Re: State Permit and Decision Package, Southern Utah Fuel Company,
Convulsion Canyon Mine Waste Rock Disposal Site, ACT/041/002,
Folder #3, Sevier County, Utah

UTAH DIVISION OF OIL, GAS AND MINING
STATE DECISION DOCUMENT AND
TECHNICAL ANALYSIS

Southern Utah Fuel Company
Convulsion Canyon Mine
Waste Rock Disposal Site
ACT/041/002
Sevier County, Utah

Figure 2

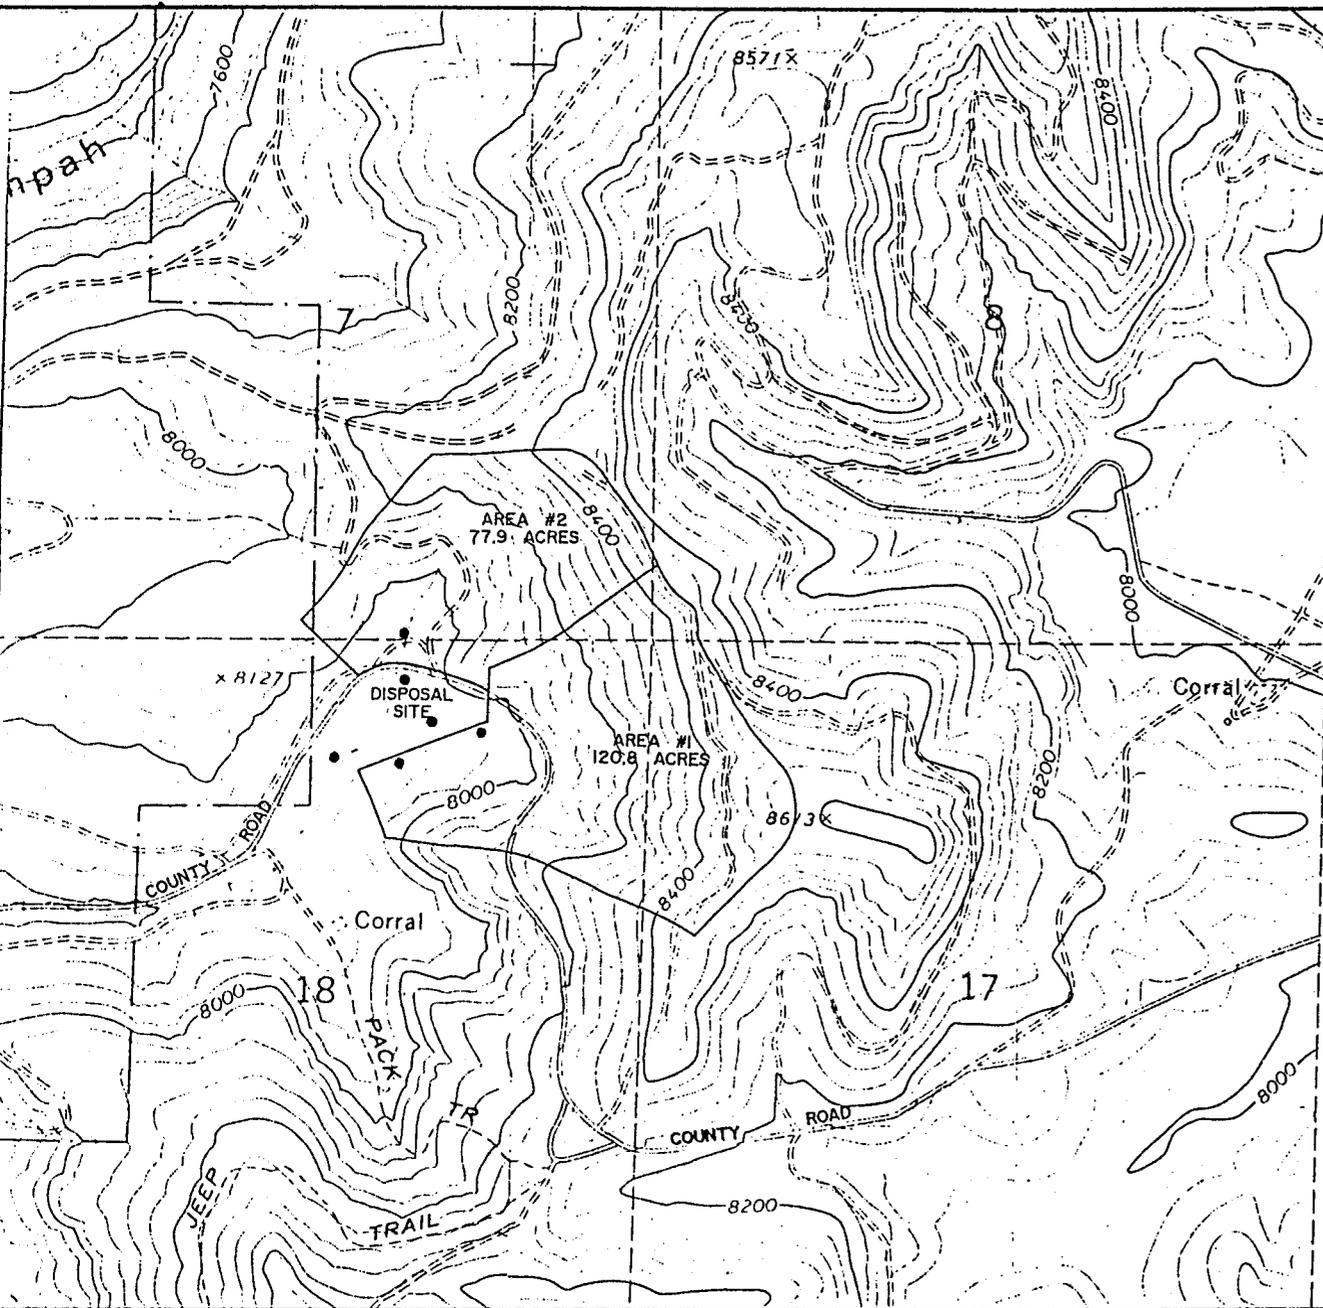
Six ground water monitoring wells (shown on Map 3 of the MRP, also enclosed as Figure 2) show ground water was encountered in the bedrock, but not in the soils and alluvium on the site. Original ground water levels in observation wells are recorded in the Well Completion Records. Subsequent water level measurements were recorded and a piezometric surface established. Data shows the piezometric surface dips 3° N. 55° S. (shown on Map 6 of the MRP).

Two ephemeral drainages (shown on Map 3 of the MRP, also shown as Figure 2 in this report) will be diverted from the WRDA via Diversions #1 and #2 (Map 2 in the MRP). The largest drainage area for these is 120.8 acres or 0.19 mile² which is less than the 1 square mile requirement of this regulation. Diversion #3, (Map 2 in the MRP) will divert a small (0.6 acre) portion of County road drainage from the disposal area.
